## **TRANSMISSION AND DISTRIBUTION SERIES**

### **AMENDMENTS AT MAY 2024**

- **IGEM/TD/1 Edition 6 with amendments. Communication 1848 (November 2021).**

#### **Steel pipelines for high pressure gas transmission**

**FIGURE 6 - MINIMUM PROXIMITY DISTANCE TO NORMALLY-OCCUPIED BUILDINGS OF PIPELINES DESIGNED TO OPERATE IN TYPE S AREAS**

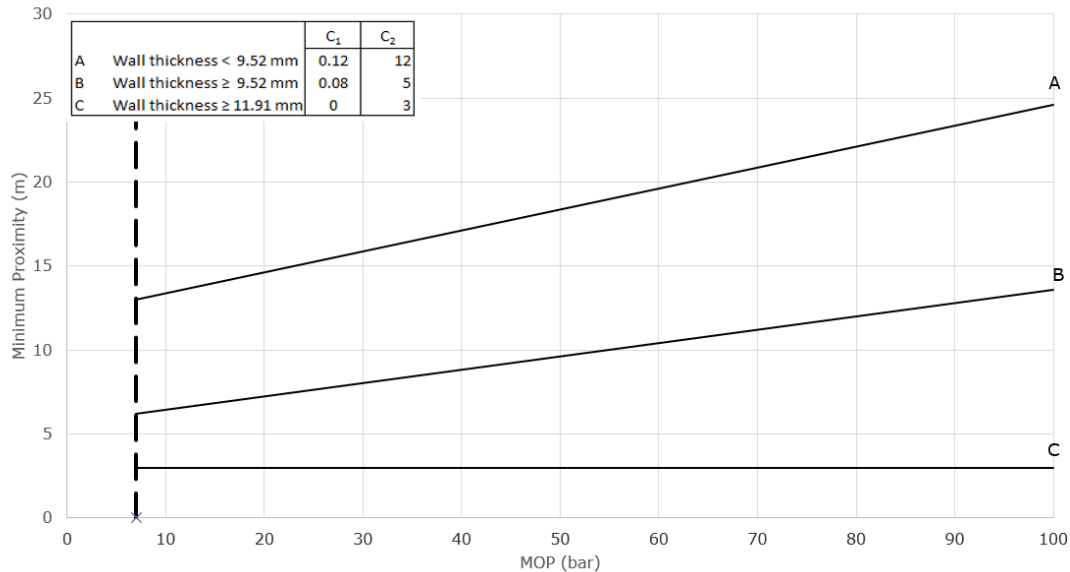
#### Correction in Figure 6

Change text of Note A from 'Wall thickness < 9.25 mm' to 'Wall thickness < 9.52 mm'

Change text of Note B from 'Wall thickness < 9.25 mm' to 'Wall thickness ≥ 9.52 mm'

Add additional text in Note 1 of Figure 6 to include 'provided that additional protection is installed in accordance with Sub-section 6.9', so that Note 1 reads:

**'For design factor not exceeding 0.3 and nominal wall thickness < 9.52 mm, a pipeline can be operated with proximities derived from curve B, provided that additional protection is installed in accordance with Sub-section 6.9'.**
